● BURBANK • GLENDALE • LOS ANGELES
 ● RAIL TRANSIT PROJECT

● Final Environmental Impact Report
 ● SCH #91101017

EXECUTIVE
 SUMMARY

**EXECUTIVE SUMMARY
FINAL ENVIRONMENTAL IMPACT REPORT
BURBANK-GLENDALE-LOS ANGELES RAIL TRANSIT PROJECT**

FIGURE 2
Alternative #1:
"Through the Jail" Alignment

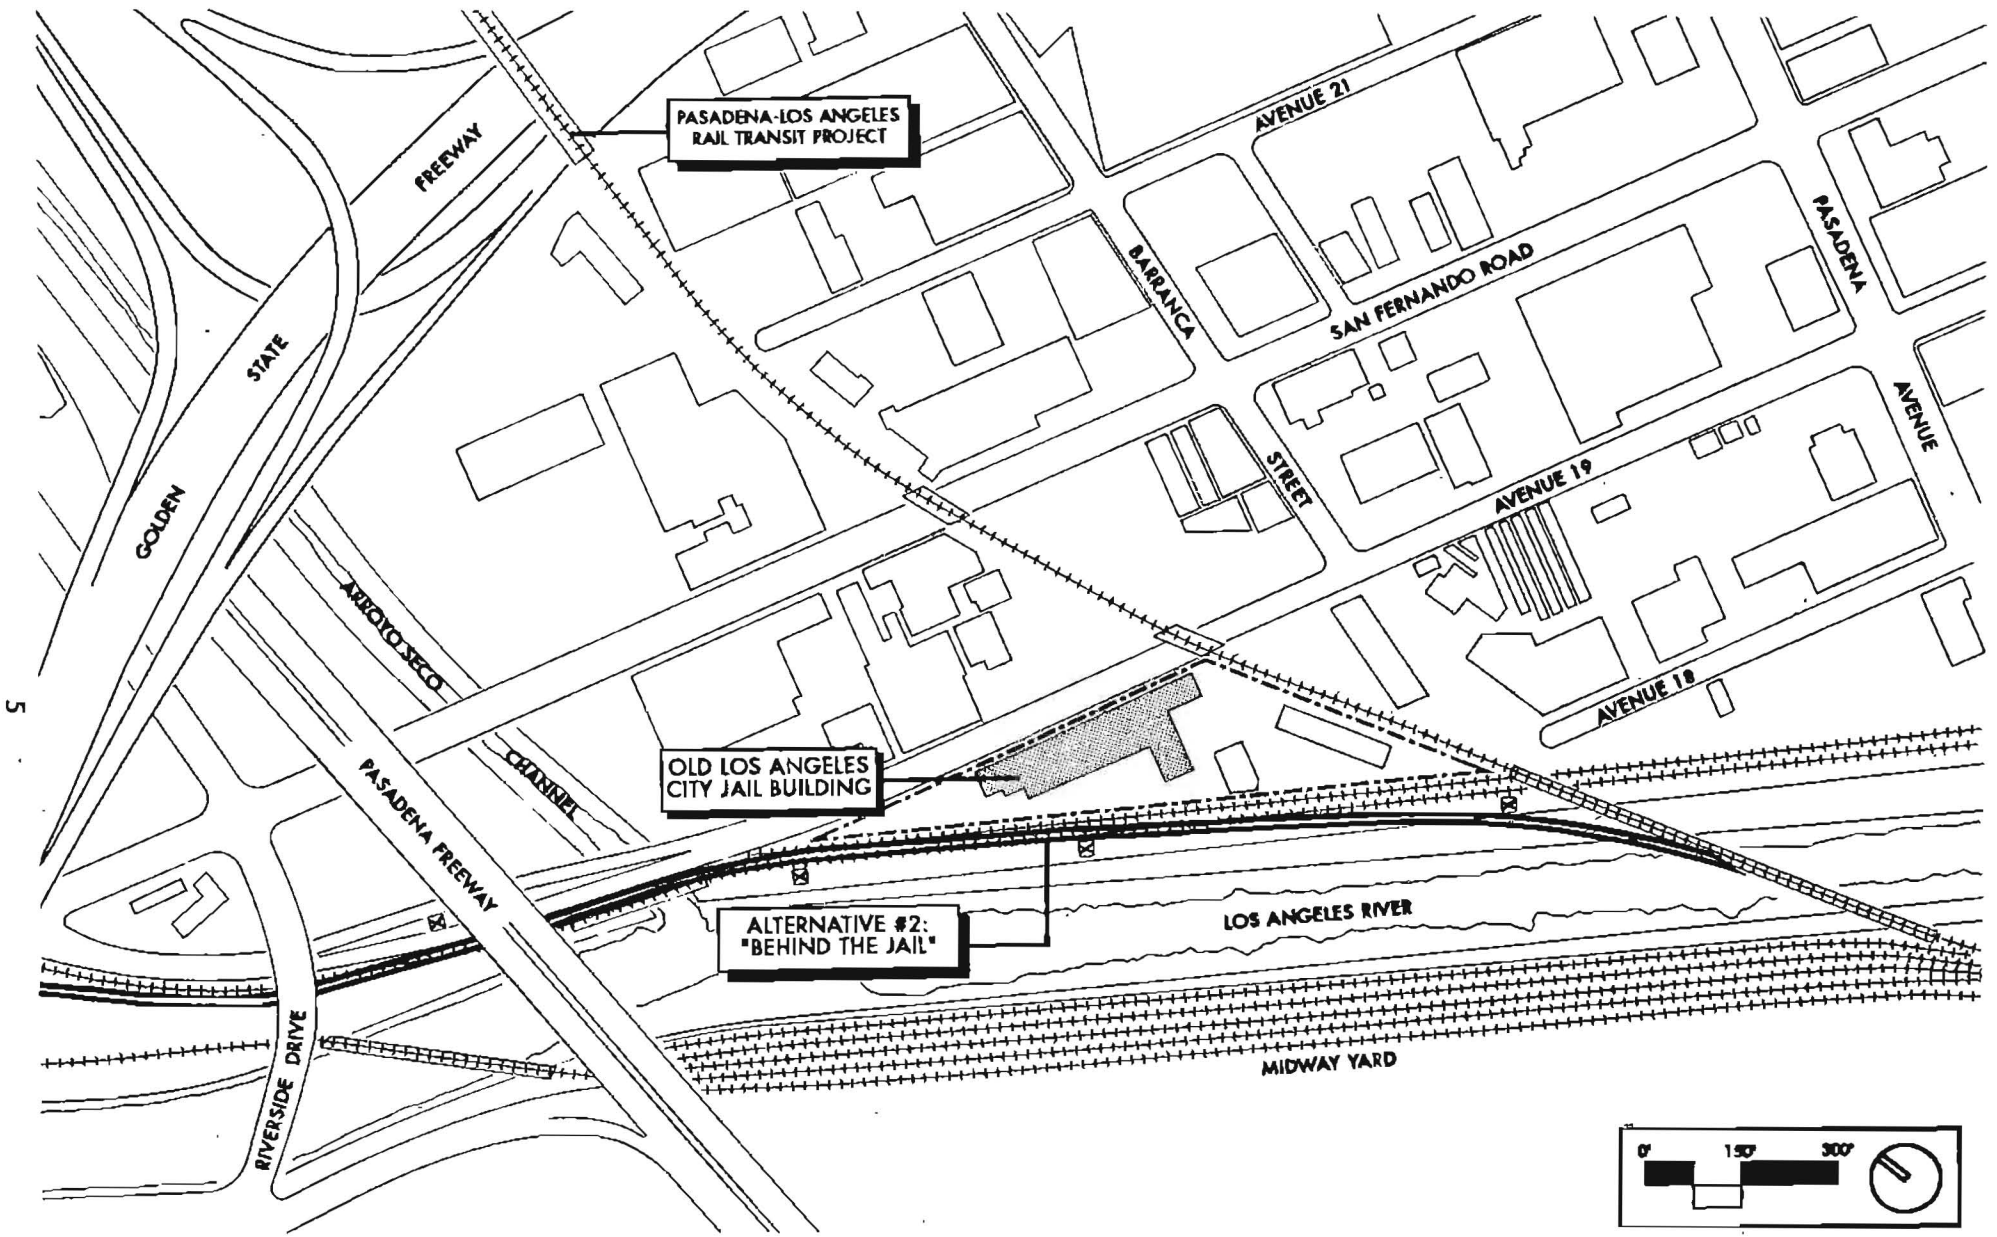
Document Reference		Responders to Draft EIR	Comment	Response
Section	Page			
5.11.2 8.4.1	-- 227	A. Los Angeles Conservancy B. Sallie Naubauer, <i>Citizens Committee to Save Elysian Park</i> @ LA PUBLIC HEARING C. Mount Washington Association D. Bill Hunter, <i>SCTA</i> @ LA PUBLIC HEARING E. Pat Moser, <i>SCTA</i> F. Alan Havens, Private Citizen	Comments on the proposed demolition of the Old Los Angeles City Jail: A. Concerned about the possible demolition of the Old City Jail, formerly the Lincoln Heights Jail, and abandonment of the Dayton Tower Signal Tower. The Final EIR should analyze alternative alignments, including one that runs to the west of the proposed alignment. B,C. Concerned and opposed to the demolition of the Old Los Angeles City Jail. Recommend that alternative alignments be studied and depicted in the Final EIR. D,E,F. Opposed to the demolition of the Old Los Angeles City Jail. Recommend that a second bridge be constructed over the Los Angeles River and design of the alignment should be placed to the west of the structure. Or study the potential of the line continuing to Avenue 26, turning north, and connecting to the SPTC right-of-way at the northern terminus of Avenue 26.	Please refer to Section 8.4.1 of the Final EIR for a comparative engineering and environmental analysis between the proposed "Through the Jail" alignment that would displace and demolish the Old City Jail Building and two alternative segments that would save the historic structure: • "Behind the Jail" Alignment • "Front of Jail" Alignment

Based on the findings of the comparative analysis, the "Behind the Jail" alternative has been removed from further consideration. Although this alternative alignment would preserve the Old City Jail from demolition, it would result in environmental impacts that include relocation of major overhead utility lines; construction of straddle bent structures and other complex forms within or near the Los Angeles River; disruption of views from the Los Angeles River and Elysian Park; and potential conflicts with an on-ramp for LADOT's proposed Alameda Bypass. In addition, this alignment would increase project costs by approximately \$9 million.

- As proposed in the Draft EIR, the "Through the Jail" alternative requires the demolition of the Old Los Angeles City Jail Building. The majority of the building is vacant, but some portions are occupied by the Bilingual Foundation for the Arts, the Los Angeles Youth Athletic Club, and the Lincoln Heights Community Youth Gang Services. The alignment, however, maximizes the potential for an at-grade alignment that would facilitate construction of the Alameda Bypass, and the mitigation measure regarding business relocation has been strengthened to allow coordination between the lead agency, the City of Los Angeles First Council District, and the existing tenants of the structure.
